Annex 1

Romania's answers sent on 5 November 2011
Regarding Potential Problems and Further Questions from the ERT, sent on 25 September 2010 (CR_ROU_2010_25 Sep 2010) and formulated in the course of the 2010 review of the greenhouse gas inventories of Romania submitted in 2010

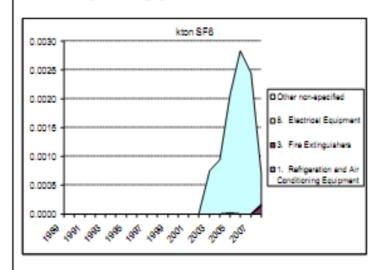
The ERT noted a 79% drop (sharp decrease) in emissions between 2007 and 2008 (see light blue shaded area in the chart below), for which explanations are not provided in the NIR or CRF. The Party did not provided responses on this issue during the review week.

The ERT considers that there is an apparent inconsistency in the time-series, and emissions for 2008 could be underestimated for this category.

Starting with 2010 submission for 2003-2008 period the actual emissions was re-estimated relative to last submission because according to the questionnaires received from the operators a new economic agent using SF6 in its activity (production of pieces and accessories for vehicles and motor vehicle) was new indentified. In 2008 the actual emissions decreased related to 2007 because the same economic agent user of SF6 has reduced significantly its SF6 consumption.
